Aircraft Make *SGS* Model *1-26 F* Reg. No. *N33917* Serial No. *637*

Bulletin No. SA-006
Date: 1 March 1989
Page 1 of 1

SUBJECT: Replacement of Seat Back Adjustment Bracket

MODELS AFFECTED: All SGS 1-26D and SGS 1-26E

FIGURE 2. TOW HOOK INSPECTION AND REWORK (SHEET 1 OF 2)

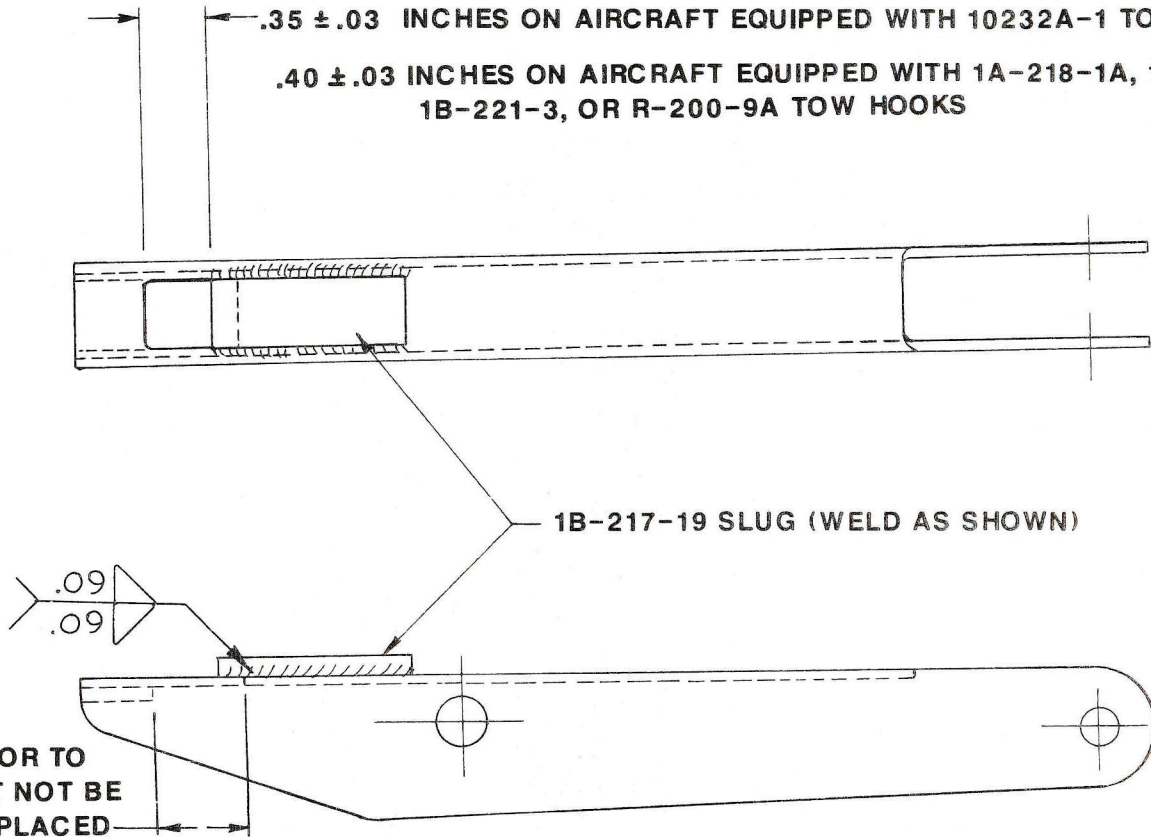
1. IF WEAR OCCURS ON SURFACE "Y" IT MUST BE POLISHED FLAT WITHIN TOLERANCES PROVIDED IN FIGURE 2 (SHEET 1). IF THE HOOK CANNOT MEET THESE REQUIRED DIMENSIONS IT MUST BE REPLACED. UNDER NO CONDITIONS SHOULD SURFACE "X" BE POLISHED OR MACHINED TO CHANGE ITS ANGLE.

3. SURFACE "Y" MUST REMAIN FLAT, SMOOTH, AND WITHIN TOLERANCES SHOWN ON SHEET 1. (SEE ILLUSTRATION.)
4. DIMENSION "C" ON 10232A-1 HOOK SHALL BE $2.06 \pm .03$ INCHES. DIMENSION "C" ON 1A-218-1A, 1B-221-1, 1B-221-3, & R-200-9A SHALL BE $3.00 \pm .03$ INCHES.

- B. Wear of the tow hook step will cause improper engagement of the hook and release. The tow hook must be inspected in accordance with Figure 2. Any tow hook which does not meet the minimum specified dimensions, after inspection and/or rework, as listed in Figure 2 must be replaced.

FIGURE 3
REWORK OF RELEASE ARM

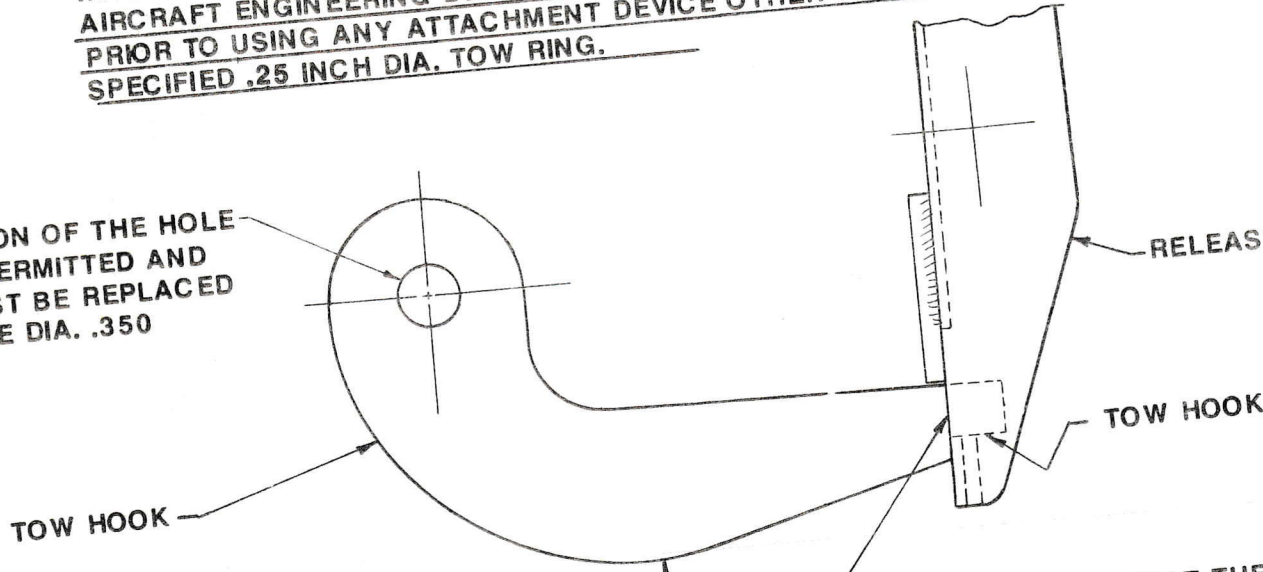
IF THIS DIMENSION IS
.66 INCHES OR GREATER PRIOR TO
REWORK THE RELEASE MUST NOT BE
REWORKED AND MUST BE REPLACED

NOTICE...ALL TOW RELEASE ARMS MUST BE REWORKED AS SHOWN
ABOVE OR REPLACED WITH THE PROPER SUPERSEDING
UNIT PER TABLE 1

- C. All tow release arms must be reworked in accordance with Figure 3 or replaced with a new superseding Schweizer release arm as listed in Table 1. If the release arm wear exceeds the dimensions given in Figure 3, rework is NOT allowed and replacement is MANDATORY.
- D. Perform complete inspection in accordance with Item 4 of this bulletin.

FIGURE 1

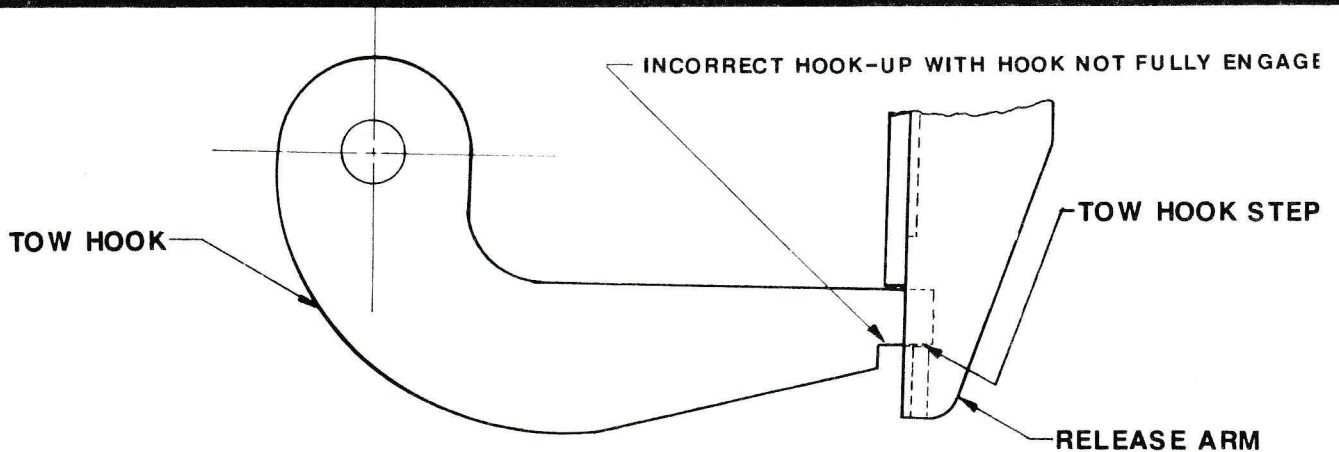
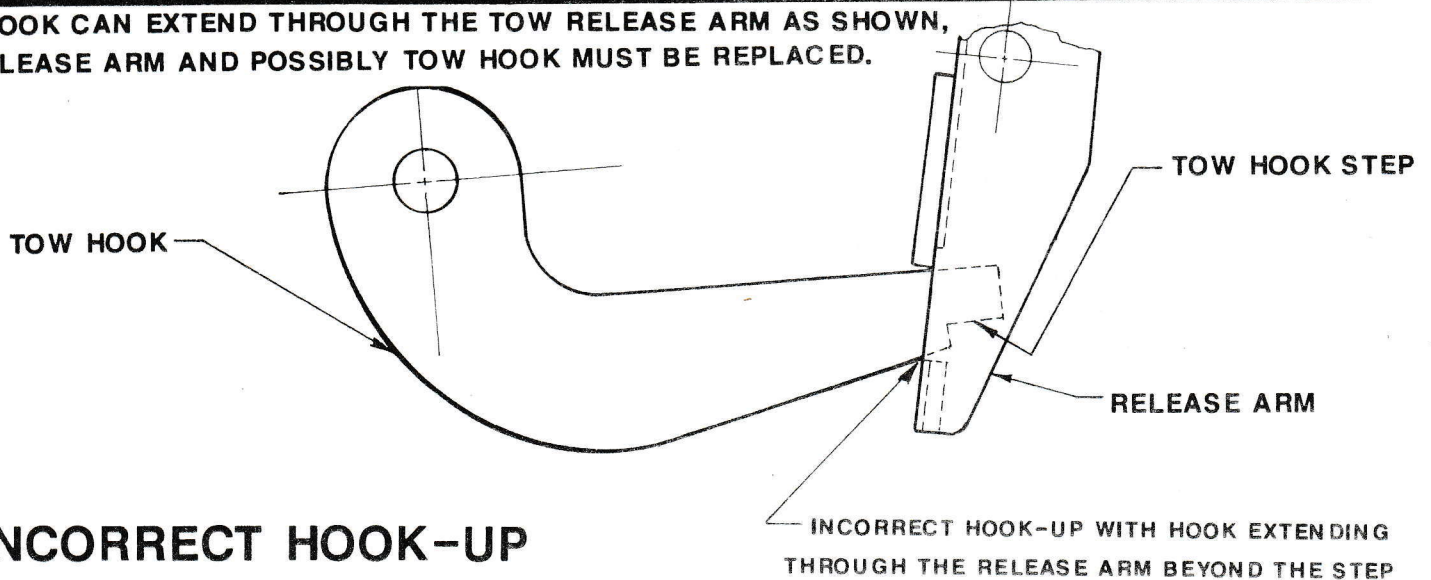
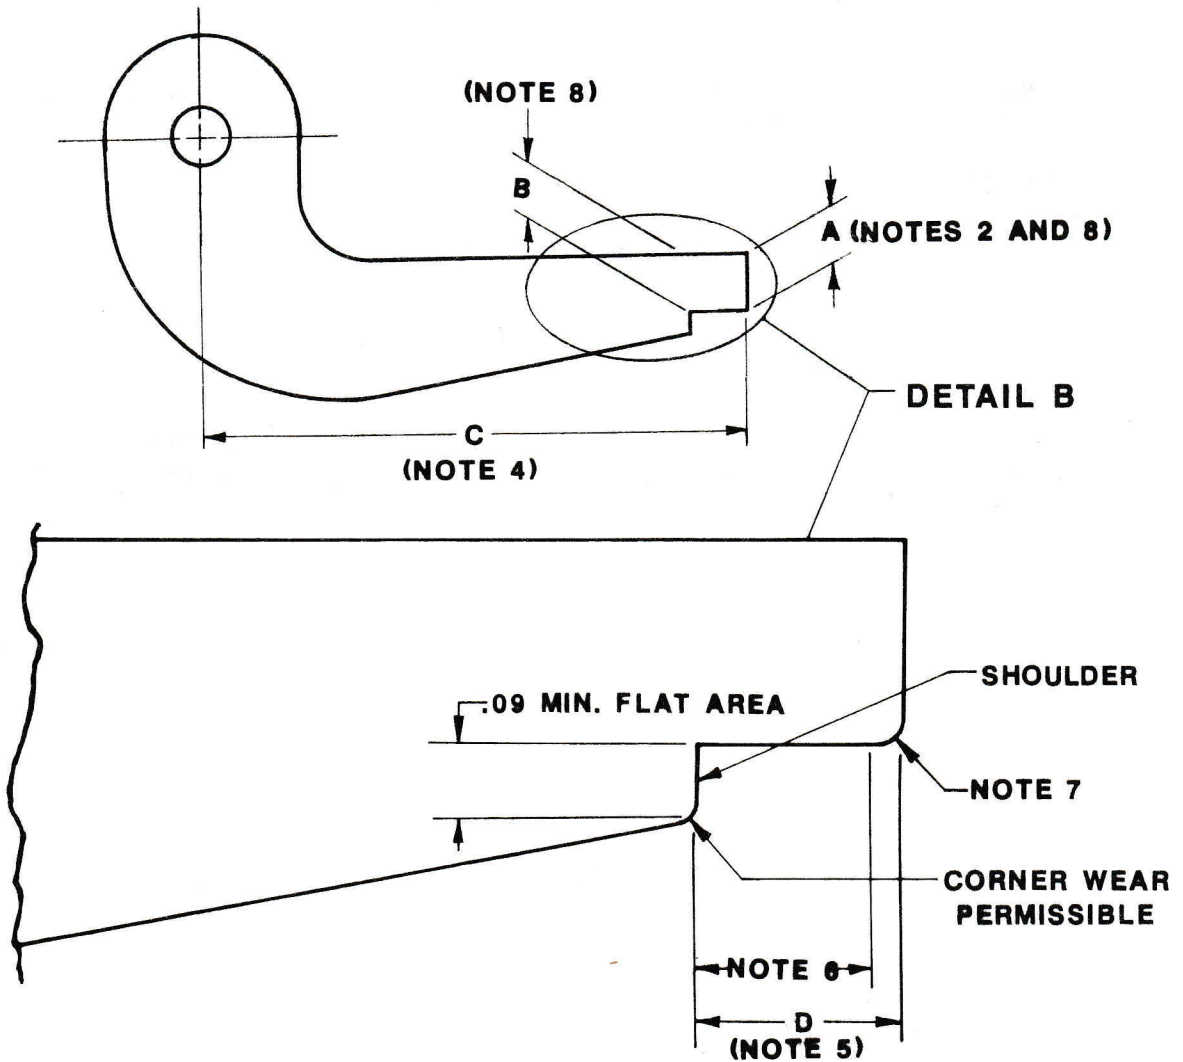
Figure 1 shows the positions for the tow hook and release arm when correctly hooked-up. Note that the step of the tow hook should be tight against the release arm assembly. The tow hook step must fully engage the release arm to allow the release assembly to work properly. The tow hook must not be allowed to extend through the release arm beyond the step on the hook since this creates a condition which defeats the design of the release and increases the possibility of an inadvertent release.

Tow hook must engage release arm in accordance with Figure 1A & Figure 4. If hook is able to pass through release arm beyond step as shown in Figure 1C, release arm and/or hook must be reworked with slug or replaced.

If tow hook fails to engage completely as shown in Figure 1B, check release control rigging. Shortening the rubber bumper stop between the release knob and instrument panel will allow the release assembly to close further.

IF TOW HOOK CAN EXTEND THROUGH THE TOW RELEASE ARM AS SHOWN, RELEASE ARM AND POSSIBLY TOW HOOK MUST BE REPLACED.

FIGURE 2. TOW HOOK INSPECTION AND REWORK (SHEET 1 OF 2)

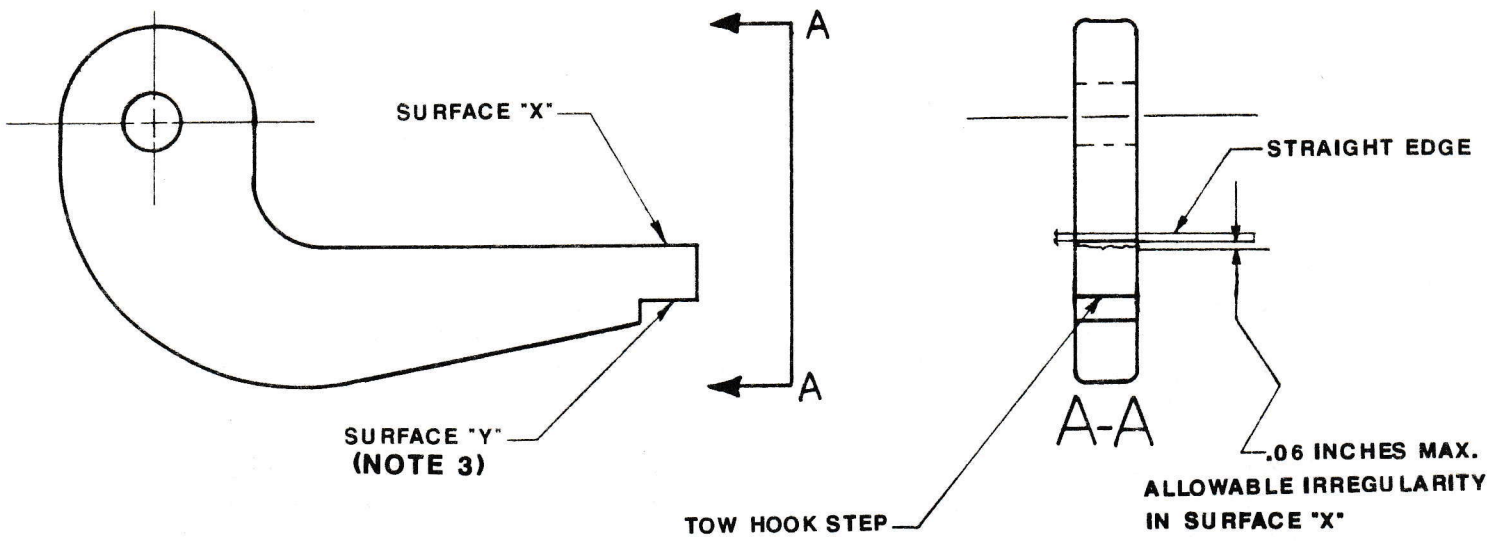
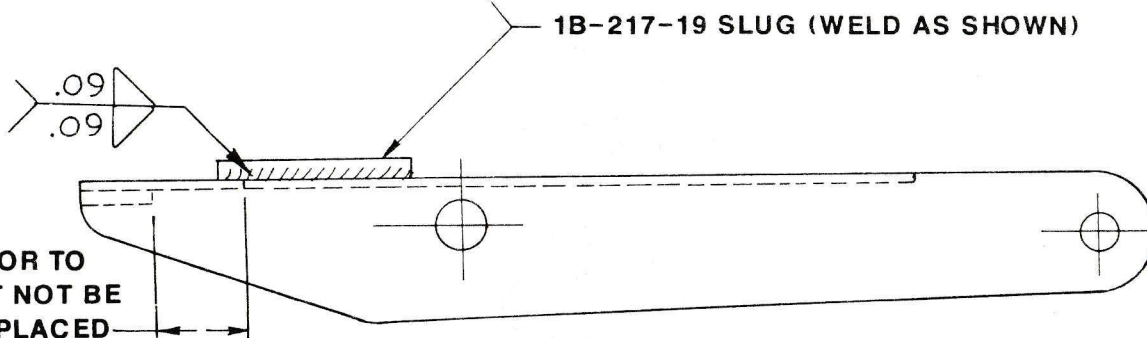
1. IF WEAR OCCURS ON SURFACE "Y" IT MUST BE POLISHED FLAT WITHIN TOLERANCES PROVIDED IN FIGURE 2 (SHEET 1). IF THE HOOK CANNOT MEET THESE REQUIRED DIMENSIONS IT MUST BE REPLACED. UNDER NO CONDITIONS SHOULD SURFACE "X" BE POLISHED OR MACHINED TO CHANGE ITS ANGLE.

3. SURFACE "Y" MUST REMAIN FLAT, SMOOTH, AND WITHIN TOLERANCES SHOWN ON SHEET 1. (SEE ILLUSTRATION.)
4. DIMENSION "C" ON 10232A-1 HOOK SHALL BE 2.06 \pm .03 INCHES. DIMENSION "C" ON 1A-218-1A, 1B-221-1, 1B-221-3, & R-200-9A SHALL BE 3.00 \pm .03 INCHES.

5. DIMENSION "D" SHALL BE .31 \pm .03 INCHES.
6. HOOK MUST REMAIN FLAT IN THIS AREA FOR A MIN. OF .21 INCHES FROM SHOULDER OF HOOK.
7. WEAR OUTSIDE OF THE .21 MIN. FLAT AREA IS PERMISSIBLE.

8. DIMENSION "B" MUST BE EQUAL TO DIMENSION "A", OR LESS THAN DIMENSION "A" BY NO MORE THAN .015 INCHES AND CANNOT BE GREATER THAN DIMENSION "A".

- B. Wear of the tow hook step will cause improper engagement of the hook and release. The tow hook must be inspected in accordance with Figure 2. Any tow hook which does not meet the minimum specified dimensions, after inspection and/or rework, as listed in Figure 2 must be replaced.

FIGURE 3
REWORK OF RELEASE ARM

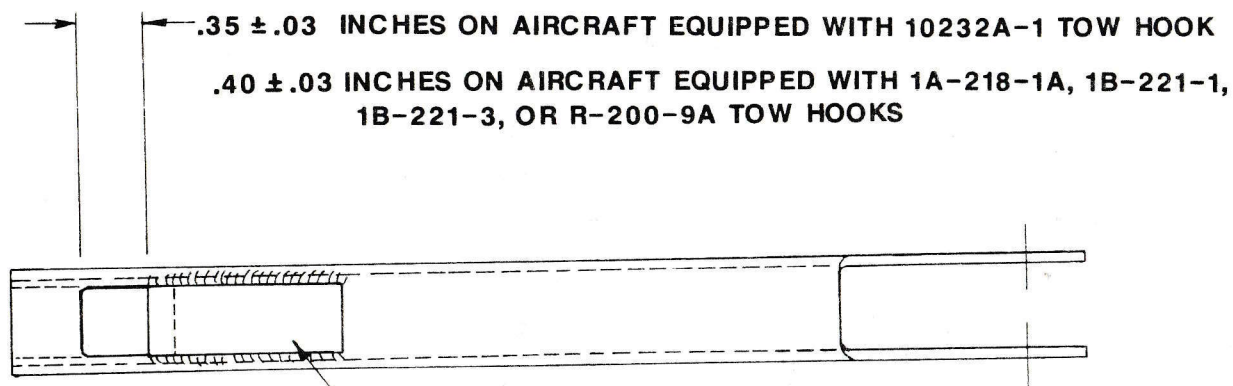
NOTE: 1B-217-19 SLUG IS AVAILABLE FROM SCHWEIZER AIRCRAFT CORP.
0.125 X 0.5 X 1.0 4130N

IF THIS DIMENSION IS
.66 INCHES OR GREATER PRIOR TO
REWORK THE RELEASE MUST NOT BE
REWORKED AND MUST BE REPLACED

NOTICE...ALL TOW RELEASE ARMS MUST BE REWORKED AS SHOWN
ABOVE OR REPLACED WITH THE PROPER SUPERSEDING
UNIT PER TABLE 1

- C. All tow release arms must be reworked in accordance with Figure 3 or replaced with a new superseding Schweizer release arm as listed in Table 1. If the release arm wear exceeds the dimensions given in Figure 3, rework is NOT allowed and replacement is MANDATORY.
- D. Perform complete inspection in accordance with Item 4 of this bulletin.

FIGURE 4

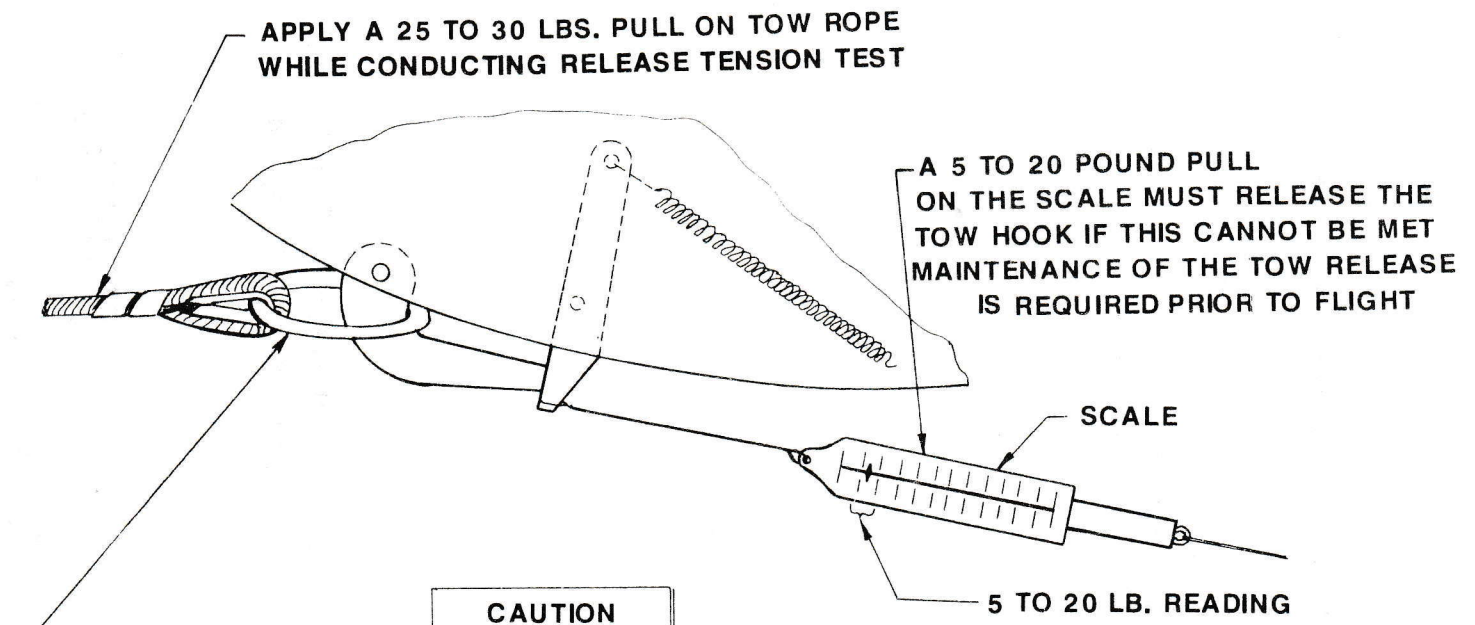
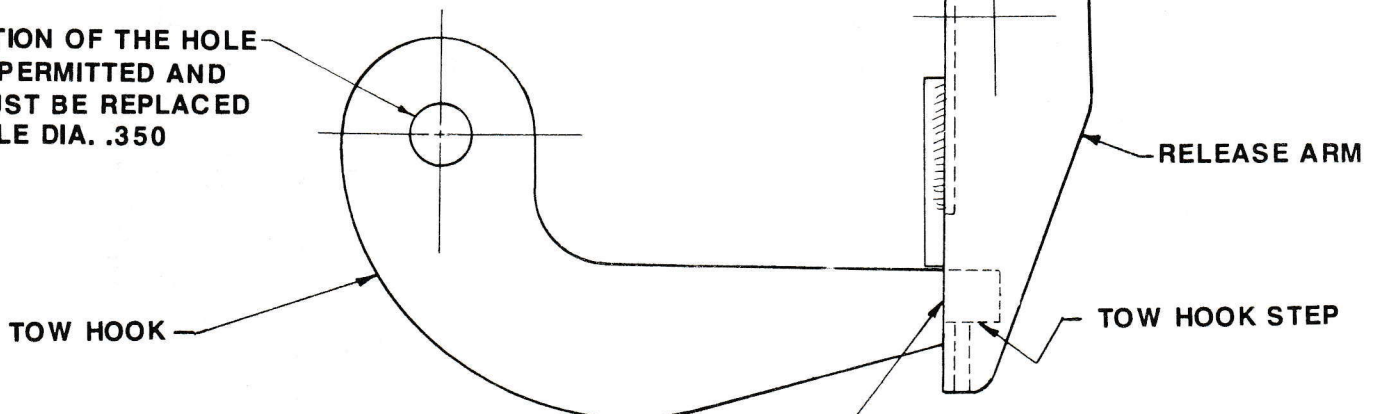
SCHWEIZER TOW RELEASES ARE DESIGNED TO OPERATE WITH A .31 INCH DIA. TOW RING. CHECK WITH SCHWEIZER AIRCRAFT ENGINEERING DEPARTMENT FOR WRITTEN APPROVAL PRIOR TO USING ANY ATTACHMENT DEVICE OTHER THAN THE SPECIFIED .31 INCH DIA. TOW RING.

ELONGATION OF THE HOLE IS NOT PERMITTED AND HOOK MUST BE REPLACED MAX. HOLE DIA. .350

ANY ROUGH EDGES MUST BE POLISHED SMOOTH AND BLENDED WITH EXISTING CONTOUR

ENGINEERING CHANGE ORDER							CHG. LET.
TITLE:	SEAT BOTTOM						
CHG. INC.		EFFECTIVITY	OPT	PARTS AFFECTED		ECO. SERIAL	26-259
BY	W.E.F.	CARD POSTED	7.20.62	TOOLS AFFECTED		D.C.R. SERIAL	—
DATE	7.20.62	CHECKED	ES 2/15/62	STOCK DISPOSITION	—	DWG. NO.	26H-318

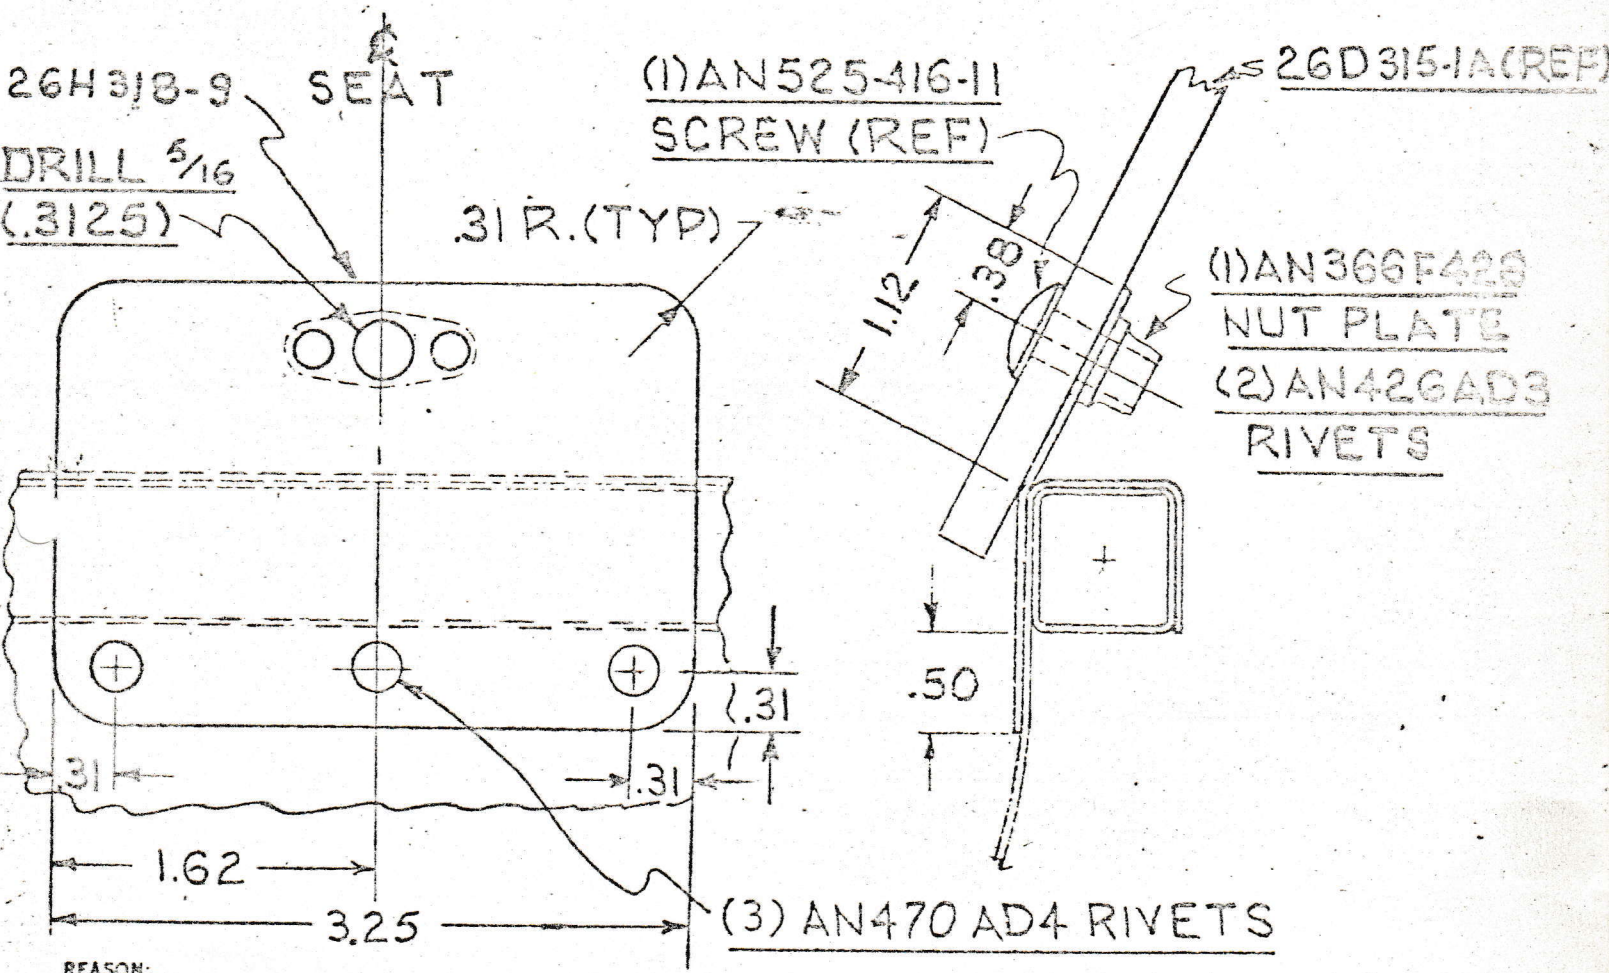
CHANGE: I. ADD ATTACH PLATE TO SEAT AS SHN.
 MAKE FROM .040 2024-T3 ALC

I. TO PROVIDE ADDITIONAL ATTACHMENT FOR SEAT BACK.
